Ward: RIDEAU-ROCKCLIFFE (13) File Number: ACS2018-PIE-RHU-0004

SUBJECT: Application for Demolition and New Construction at 50 Lakeway

Drive, a Property Designated under Part V of the *Ontario Heritage Act*and located in the Rockcliffe Park Heritage Conservation District

Document 4 – Site Plan and Landscape Plan

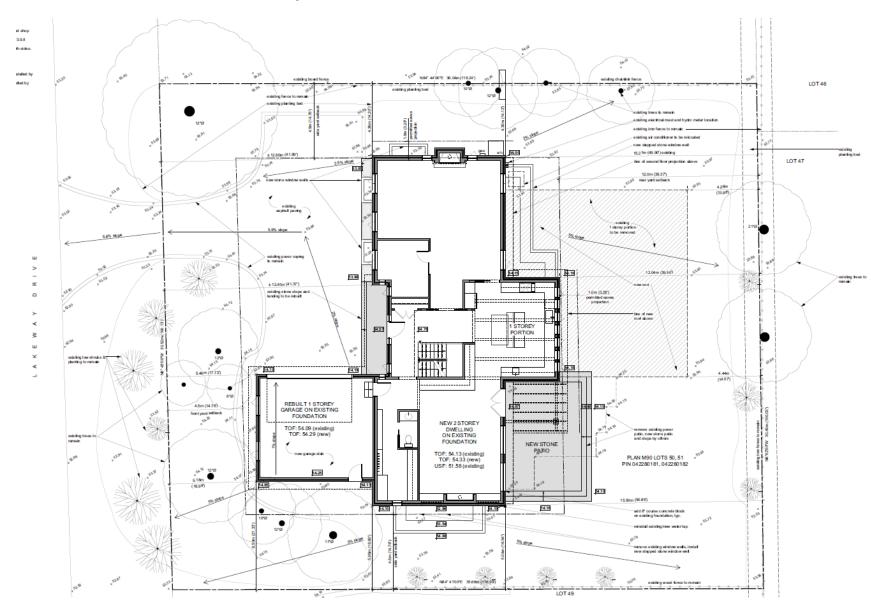
The proposed landscape plan includes the retention of existing trees and shrubs. These trees act a visual buffer along the street (see Document 4 and 7).

The proposed plan includes the removal of a portion of the rear of the building. This will dramatically increase the soft landscaping of the rear yard.

This proposal meets the requirements of the new RPHCDP with regards to landscape as all the mature trees and shrubs will be retained, and the rear yard will be enhanced and enlarged by the removal of a portion of the rear of the house.

Document 5 - Elevations

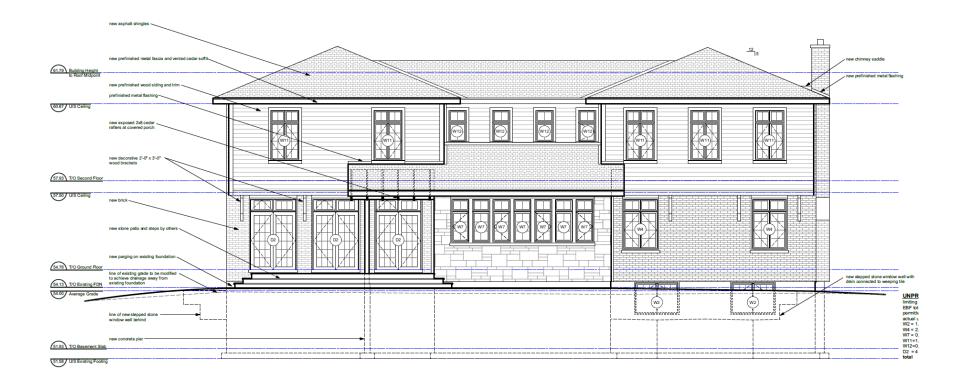
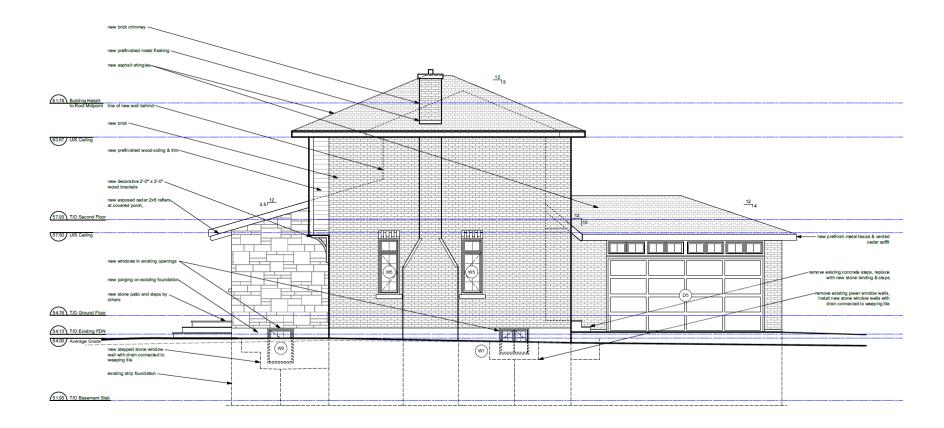
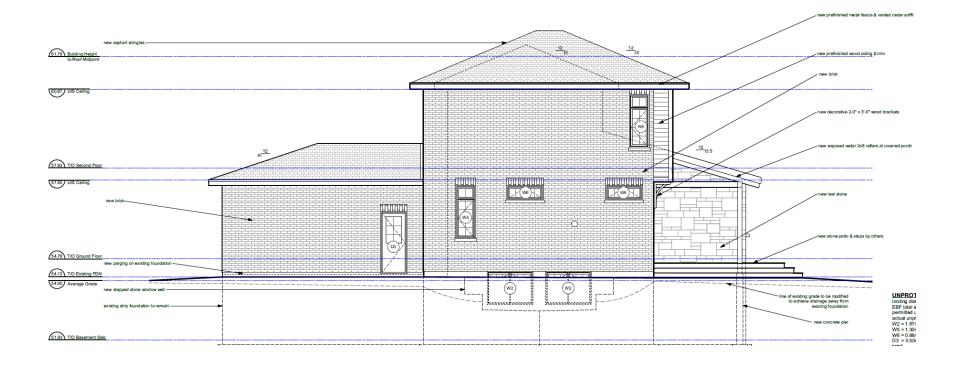
The applicant proposes to replace the existing structure with a two-storey building with a sloped hipped roof, and rectangular plan. The existing foundations will be used, with the exception of a portion of the rear of the house, which will not be built upon. This will result in a smaller footprint than the existing house, and allows for a larger landscaped rear lot. The garage will remain in the same location in front of the house, with the same T-shaped driveway. The new house will be clad in stone, grey brick and wood siding (see Documents 4 -7).

The proposed house is consistent with these guidelines. The new building will have a hipped roof, rectangular plan, and use natural materials.

The proposed building respects these Guidelines. The orientation, height and massing of the building are compatible with the character of Lakeway Drive. The house has been designed so that the height of the proposed building is consistent with its adjacent neighbours. A minor variance is required for the interior side yard setback, an existing condition.

The new building will maintain the setbacks of the existing building and is consistent with neighbouring houses on Lakeway Drive.
